MFN 08-224

Subject: **Response to Portion of NRC Request for Additional Information Letter No. 98 - Related to ESBWR Design Certification Application – RAI Number 4.4-57**

RAI Number 4.4-57

DCD Markups from the Response to RAI Number 4.4-57

Figure 4D-3. Core Average Axial Power Shape at Different Exposures

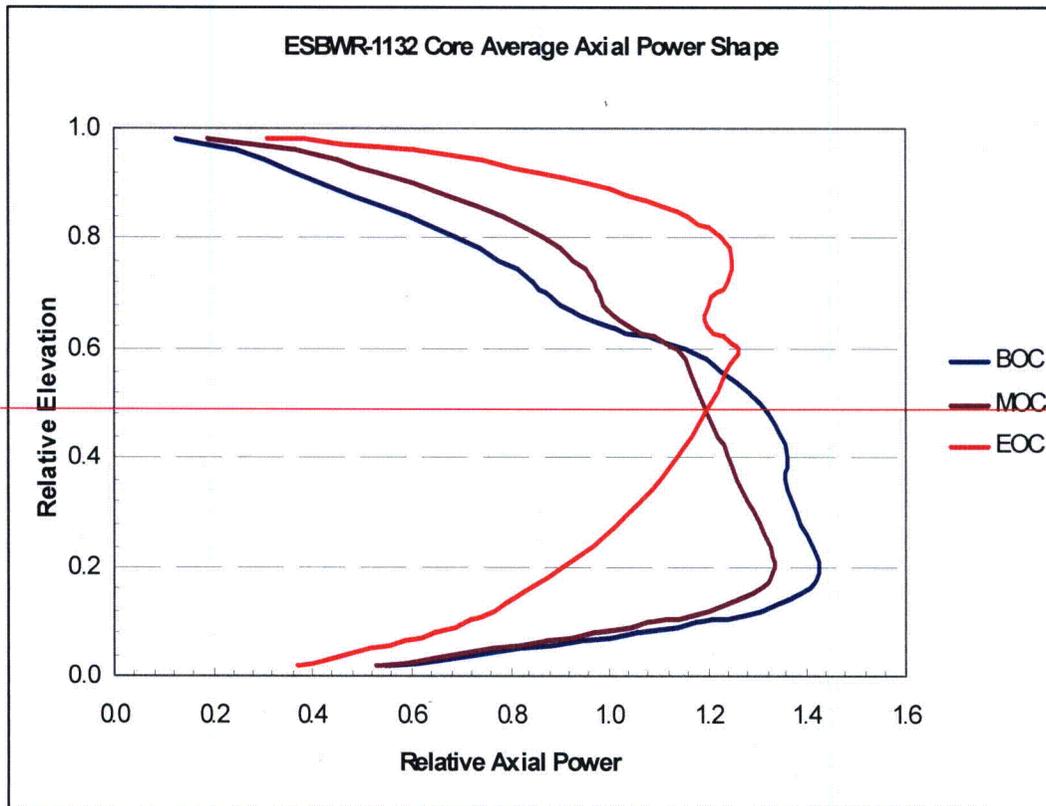
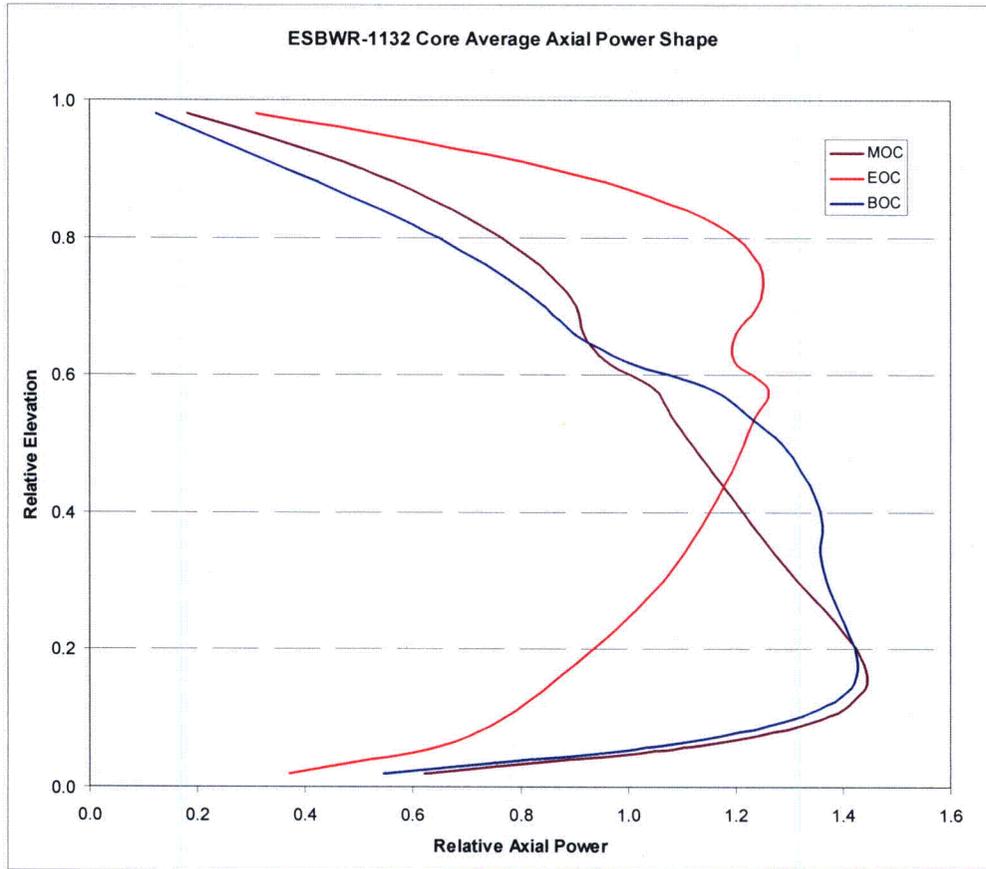
DCD Tier 2, Chapter 4, Subsections 4D.1.3 and 4D.1.5; Tables 4D-1, 4D-2 and 4D-4; and Figures 4D-3 and 4D-5 will be revised in Revision 5 as noted in the enclosure 2 DCD markup.

A baseline analysis was performed for the ESBWR at rated conditions, which are the most limiting from the perspective of stability due to the highest power/flow ratio Reference 4D-11. Analysis was conducted for equilibrium GE14 core at various points in the cycle: BOC, Middle of Cycle (MOC) ~~at near~~ the Peak Hot Excess (PHE) reactivity cycle point~~peak reactivity~~ and End of Cycle (EOC). The initial conditions are tabulated in Table 4D-1. The core average axial power shapes for the three exposure points are shown in Figure 4D-3. Additional analysis was conducted at points with small exposure increment through the cycle in order to make sure that the limiting exposure level in terms of Regional Stability is identified. Based on the analysis results, it is determined that the limiting exposure is at the Peak Hot Excess (PHE) cycle point for the equilibrium core.

Figure 4D-5. Stability in Expanded Operating Map

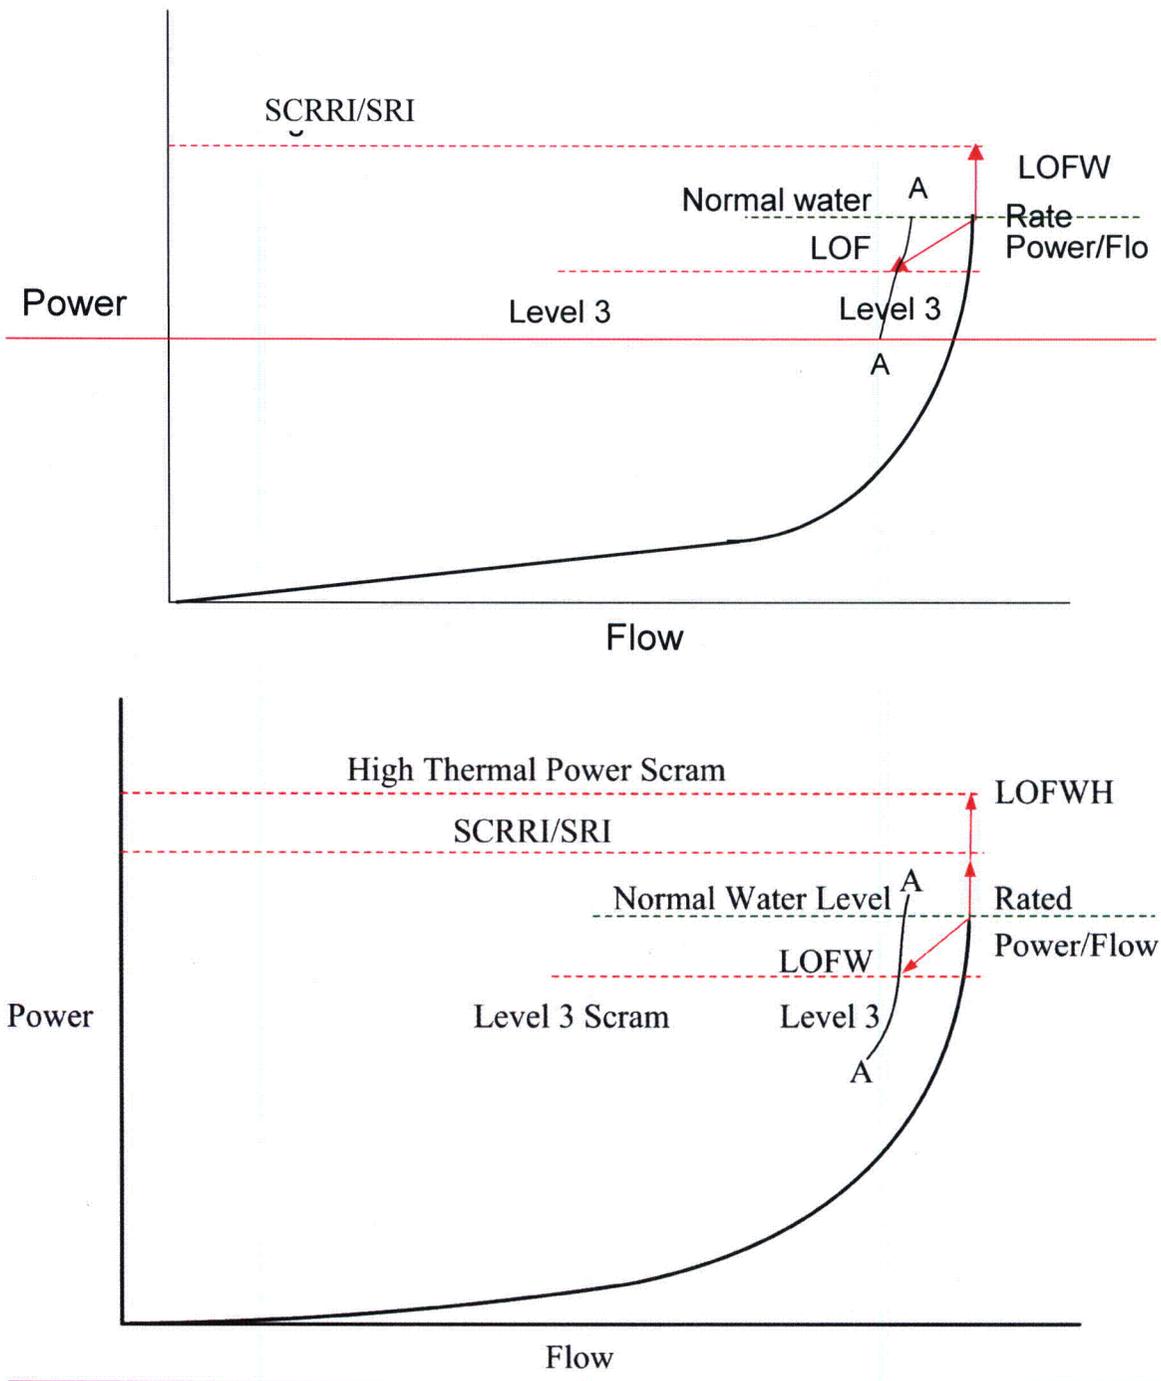
Two limiting AOOs were identified based on the above discussion: Loss-of Feedwater Heater (LOFWH), which results in increased power; and Loss of Feedwater Flow (LOFW), which results in a lower flow. The trajectories of the transients in the power – flow map are shown in Figure 4D-5. The curve A-A corresponds to operation with a reduced level in the downcomer. The lower level leads to a reduction in flow. Different points on A – A correspond to changes in control reactivity or changes in core inlet subcooling.

LOFWH is a slow transient, in which the power increases slowly as the feedwater temperature drops. If the operator takes no action, the power would increase until a high thermal power scram occurs at 115% of rated power. SCRR/SRI is initiated at 30°F reduction in feedwater temperature. The worst operating point would be one where the drop in feedwater temperature is about 30°F such that the power increases to just below the setpoint a higher value (~10615%) than rated and levels off at that value.
